Planning Application: 253074: Land adjacent to School Road and Orchard Road, Hurst (Willowmead Fields) Application for Approval of Reserved Matters

Submitted by: A Butler

View northeast to INFL1A top, view to east bottom

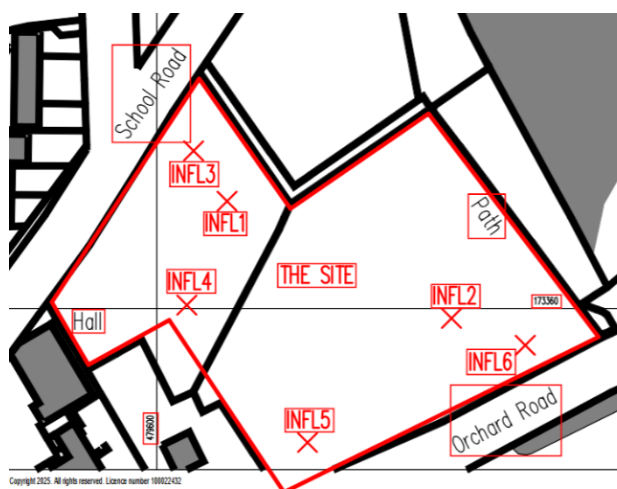
The photo to the left is the Applicant's own photo of the site taken from the School Road direction, orientated similarly to the photo showing 1st April 2023 flooding. Except this Applicant's photo was taken in drier Summer conditions, with the trees in full leaf, and with the Willowmead fields overgrown and ungrazed (before weedkiller application).

The same Applicant's photo appears in both the **Drainage Report** and **Infiltration Test Report** documents but with slightly different titles, the other

identical photo annotated "View northeast to INFL1 top, view east to INFL2 bottom". The change in titles and test pit nomenclature is a clue to data manipulation which is due to either a lack of care, or due to what might be interpreted by some as a deliberate attempt to confuse and knowingly deceive to falsely gain approval for an unrealistic scheme which from local experience is certain to cause serious future flooding harm to many near, and not-so-near, Hurst residents.

Infiltration Test Report (left)

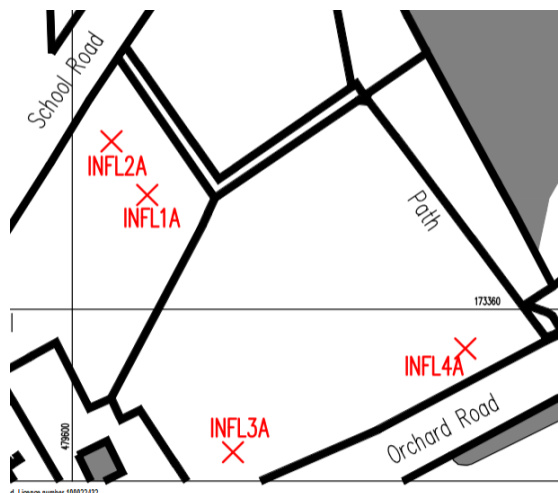
Comparing locations of the infiltration test pits in the two documents, the Infiltration Test Report photo description of the view from School Road "east to INFL2 bottom" is correct, but INFL2 is then not referenced in the Drainage Report.

Test pit INFL4, located near the north corner of Willowmead's garden fence and in the lower flooded area at 38.50m AOD, had relatively poor infiltration results - and has been deleted in the Drainage Statement, viz: **INFL4 0.3m DipmBGL to 0.6m in 2400 (mins)** – taking perhaps 40 hours to soak away a foot of water?

Test pit INFL6 at 39.50m AOD, at a huge elevation difference for Hurst (1m higher than test pit INFL4), consequently provided much better infiltration results, viz: **0.35m DipmBGL to 07m in 900 (mins)** taking only 15 hours to soak away more than a foot of water. This test pit has been renamed INFL4A – making it look a bit like INFL4; why not use INFL6A – when INFL1 has logically become INFL1A etc? At best this erratic change in nomenclature is just confusing.

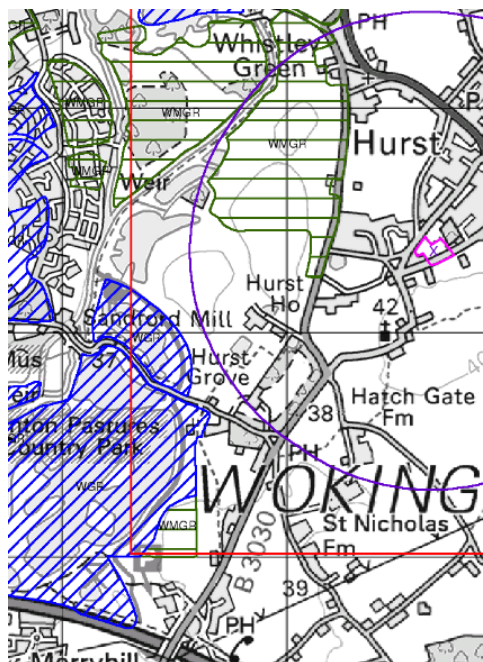
The Applicant has incorrectly assumed there are no public surface water sewers. There are surface water sewers, the road drain (photo right) is in School Road immediately outside the Village Halls. The photo was taken to show how agricultural activity involving large tractors and trailers can regularly block Hurst's surface sewers in summer as well as the normal blockage with leaves in Autumn/Winter. The expected surface water run-off from the Willowmead fields site shown in the applicant's **Appendix E FLOOD EXCEEDANCE PLAN** will either flow over and into this road drain, left to right, or help block it with "agricultural trailer" debris.

Thames Water and WBC must be consulted on the Applicant's proposals to utilize School Road's surface water sewer, and Interested Parties need to see a satisfactory TW and WBC response before WBC approval is given for a proposed drainage scheme. It is also clear from this oversight and from the applicant's lack of attention to using accurate street and school names, the Applicant has spent little or no time in Hurst to actually look at, properly survey, and properly assess the site location in context with its surroundings.

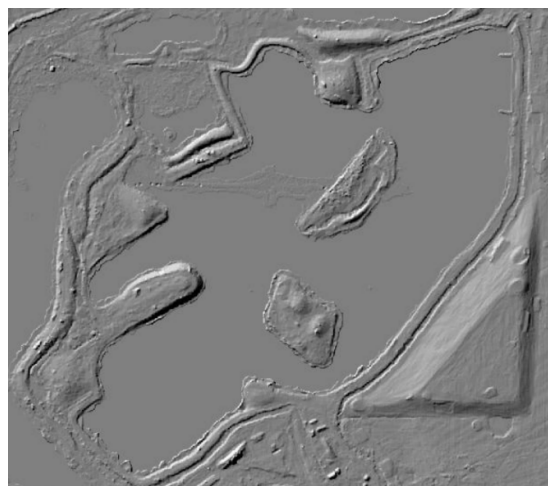
This **Landmark map Page 2 of 5** is meant to indicate those areas where the ground surface has been significantly modified by human activity – which Wokingham Borough Council Planning knows all about and at some time must have approved. A main reason for the current pluvial flooding problems within Hurst is the 2 million tonnes of general waste deposited over 50ha of Hurst's River Loddon floodplain west of Lodge Road. These landfill hills now block all surface water drainage west and north directly to the River Loddon from **C2: Hurst Terrace**. These capped waste landfill hills now cover and block EA

Main Rivers (or drainage ditches) that previously existed in this area. Unlike the current misleading Ordnance Survey map, the Landmark map does correctly show the 40m contours of the three distinct landfill hills northwest of Hurst Hill. But inconsistently, the waste hills with their gas collection system and perimeter leachate segregation ditch, are not marked as “ground surface significantly modified by human activity”. Similarly, west of Davis Street, the raised level of Dinton’s embanked Black Swan Lake reservoir/stored water above Flood Zone 3 level, and the surrounding raised landscaping replacing and displacing original floodplain, is clearly marked in blue hatching but not the man-made, gravel-waste, and distinctive triangular old golf course hill, which shows up clearly on LiDAR (right above) – a man-made raised feature that again now helps to trap increased redirected surface water run-off and pluvial flooding within Hurst village.

Hence, unless this document allegedly highlighting the bigger picture regarding man-made topographical change around the proposed site is corrected, it serves absolutely no useful purpose and should be retracted by the Applicant. It simply contributes to misunderstanding and misleading statements such as in the Applicant’s [Drainage Statement, Drainage Strategy Report, 2.0](#) “[The nearest watercourse is the River Loddon...](#)”. Correct as the crow might fly but not in terms of ground level where water flows to the lowest point. With waste-contaminated man-made features now blocking any direct flow west, Willowmead fields run-off surface water will tortuously seep and drain south into Hurst’s still active “EA Main Rivers” beyond Church Hill. First alongside Lines Road towards Hatch Gate Farm and across towards Keyers Bridge, then beyond A321 in the Broadcommon ditches, and on into Twyford Brook and only then discharged to the River Loddon and River Thames.

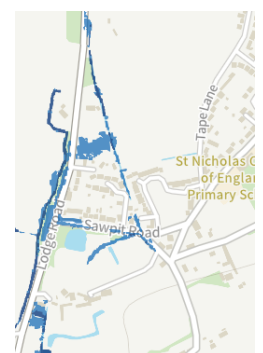
On the left the GOV.UK map shows an impossible strip of maximum Flood Zone 3 risk on top of Hurst’s western waste landfill hill – several metres above actual Zone 3 flood level. On the right the landfill perimeter ditch is wrongly shown ending and is not shown at all north of Old Lodge/Summerleaze Lodge Road site entrance. This new ditch running north close to Lodge Road, provides a conduit for zone 2 and 3 flooding into central low-lying Hurst for both preferential Zone 3b River Loddon fluvial

flooding, increased “capped” landfill surface water running east towards Hurst, and Black Swan Lake “Wet Day” reservoir flood risk. The full extent of the ditch should be shown; why is it missing and when will these obvious errors be sorted out? Meantime WBC should not rely on this information for Hurst flood risk assessments or recommend its use to others. In para (64) of the Willowmead Appeal Decision, the Inspector has abdicated responsibility by stating “[I was told though that the site is in Flood Zone 1](#)” – placing responsibility on Wokingham Borough Council’s word that the Willowmead site floods once in a thousand years! Who will be legally responsible for an incorrect decision causing significant increased flooding harm - bearing in mind GOV.UK Flood Zone data is now known by WBC Planning to have easily-checked flaws?

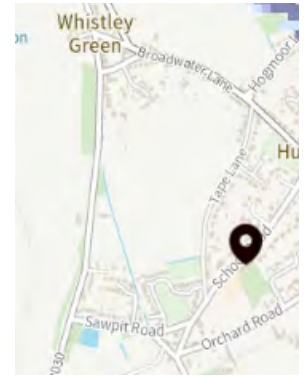
Also, unlike the fluvial flood zone map, the GOV.UK surface water data does in fact show the existence of the Hurst Landfill segregation ditch north of Old Lodge/Summerleaze site entrance. These errors and discrepancies, highlighting not only the presence of errors within maps but between GOV.UK flood maps, surely point to a need to base any credible Willowmead fields drainage proposals on actual site survey

(4.1.1) For Willowmead fields specifically, the Applicant has submitted an allegedly GOV.UK flood zone map showing a remarkable absence of surrounding local fluvial flooding: Specifically looking at GOV.UK data submitted with this planning application for Willowmead fields, a screenshot (right) shows the Applicant's submitted flood zone map ([Drainage Strategy Report 1.1 Fluvial Flooding](#)). The site marker is on St Nicholas Primary School (not the site) with accompanying text claiming the site is Flood Zone 1. Comparison with the current GOV.UK flood zone map (screenshots above in 4.1) shows that all Flood Zone 2 and 3 flooding predictions either side of Lodge Road/Sawpit via the landfill segregation ditch and impinging on vulnerable areas of Sawpit and Lodge Road, are just not present. With the text suspiciously stating "[Yearly chance of flooding between 2036 and 2069](#)", is there a GOV.UK prediction for the River Loddon to run dry before 2036? The Applicant's presentation of clearly bogus, inappropriate flooding data in the guise of believable GOV.UK data, would be consistent with what looks like an inconsiderate, deliberate intention to deceive, or at best mislead. But much more serious than this one-off Application misrepresentation is the change in surface water flooding data predicted by the GOV.UK March 2015 roll-out described in (4.2) superseding more accurate Willowmead fields App: 230074 data.

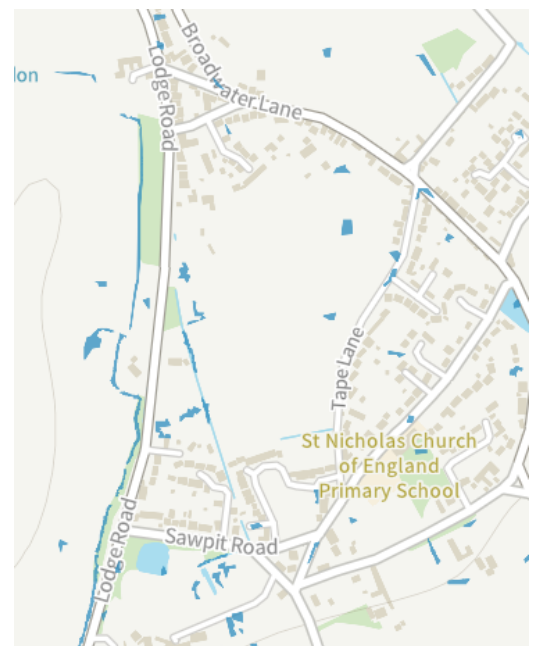
In the screenshot (right), the new theoretical, and severely downgraded unrealistic 30-year flood risk predictions rolled out in March 2025 are a misleading travesty; don't be fooled into thinking that just because this is a new government/EA/OS roll-out it is an improvement! This appears to have been a government-backed data manipulation exercise to downgrade apparent surface water flood risk without reference to actual flooding history. A possible purpose being perhaps to make it easier allow developers to override legitimate local objections and build on land which floods?

This latest GOV.UK prediction (right) with the [Figure 5.2: EA Updated Flood Map for Surface Water](#) can be compared with the original CampbellReith Flood Risk Assessment and Drainage Strategy submitted for Willowmead App: 230074. The superseded prediction more closely matches the actual surrounding frequent flooding experience. For example, roads surrounding the proposed "Land North of Hogmoor Lane" site pictured below apparently no longer flood.

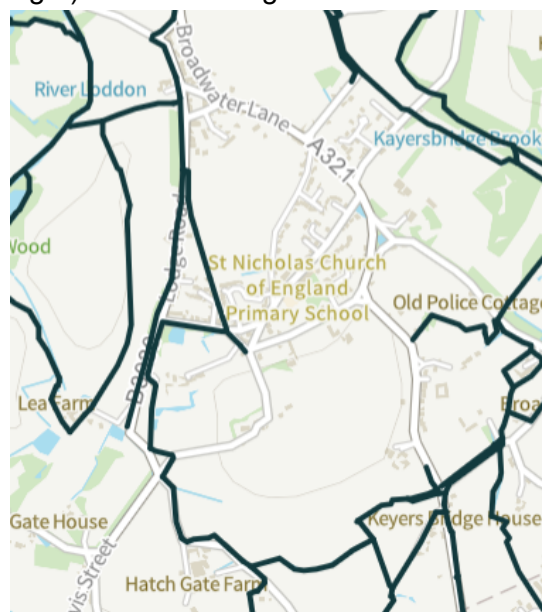
(4.3) Update of online Environment Agency EA Main River data is long overdue: EA Main Rivers (local ditches), shown on GOV.UK Flood maps (screenshot right) are misleading and inaccurate - showing digital virtual EA Main Rivers (drainage ditches) that no longer exist, displaced by Hurst Landfill a generation ago. Particularly relevant to Hurst, are the now non-existent northern sections of the Hatchgate Ditch directly connecting with the River Loddon - still wrongly and very misleadingly shown as potential waterways for onward drainage to the north and west of Hurst. All increased surface water run-off from the Willowmead fields development will now take the tortuous southern/eastern route, draining first towards Sawpit, Lodge Road, and then south and east around Hurst hill towards Keyers Bridge – contributing to “S-19” flooding.
